PLANNING COMMITTEE MEETING - 6th March 2019

Amendment/De-brief Sheet

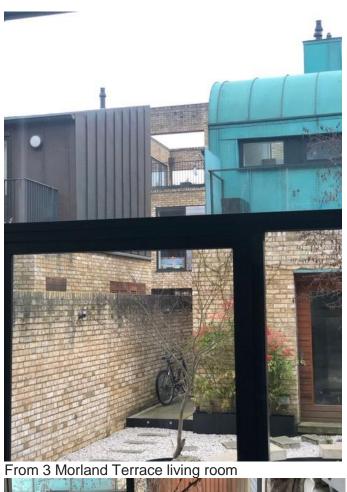
This photograph does not show 12 Gilmour Road, but it demonstrates the style of the whole estate. It illustrates the density of the pattern of building, and shows how large numbers of terraces and private spaces are overlooked from other houses.
